UNITED STATES PATENT AND TRADEMARK OFFICE

10/658,316

Office Action Summary

DETAILED ACTION

FIG. 2

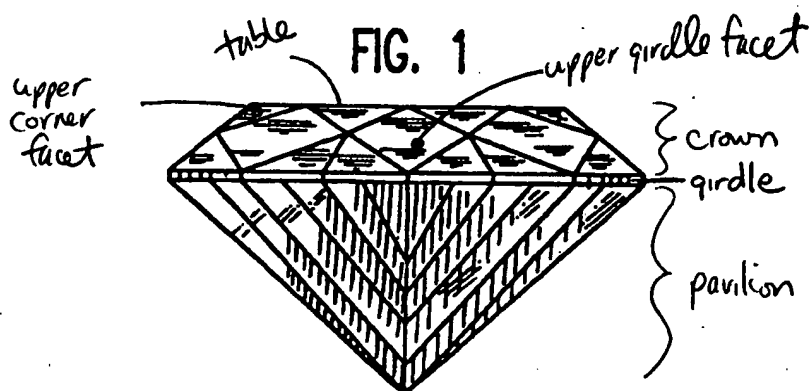
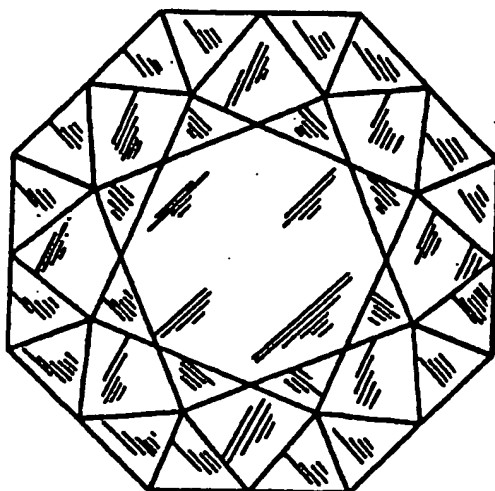
3. Claims 1 and 3-6 are rejected under 35 U.S.C. 103(a) as being unpatentable over Schachter (US#D340670) in view of Friedman et al. (US#6430963).
4. Regarding claims 1, 4, and 5, Schachter discloses a brilliant cut gemstone comprising: a brilliant cut crown on an upper side of a girdle including upper girdle facets and upper corner facets; the girdle having plane comprising 8 sides and shaped as an "approximately" equilateral octagon (Fig. 1); the corner facets spaced from the girdle (Fig. 2); and a pavilion located on a lower side of the girdle. Note: See annotated Fig. 2.

FIG. 3

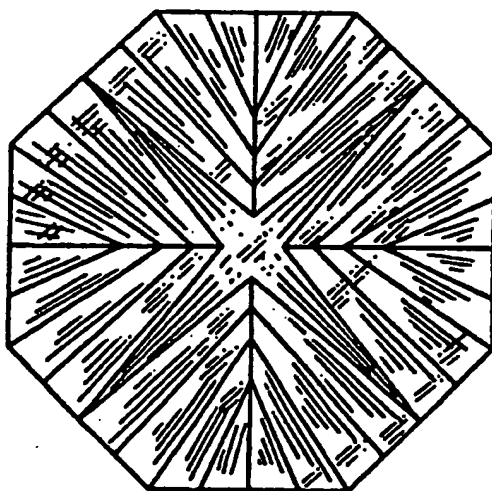
5. Regarding claim 1, Schachter fails to disclose the pavilion including lower girdle facets, bezel star facets, and lower corner facets wherein the angle between a table and the lower girdle facets is approximately 50-60 degrees. However, Friedman teaches in Fig. 3 a brilliant cut gemstone wherein the pavilion 30 includes lower girdle facets 32, bezel star facets 42, and lower corner facets 34 wherein the angle between a table 16 and the lower girdle facets is "approximately" 50-60 degrees (Fig. 3). This pavilion configuration enhances the brilliance of

6. Regarding claim 3, Friedman teaches the angle between the table and bezel star facet is “approximately” 38.1 to 43.5 degrees (Fig. 3).

7. Regarding claim 6, Friedman teaches the angle between the table and lower corner facets is “approximately” 40.1 to 46.9 degrees (Fig. 3).
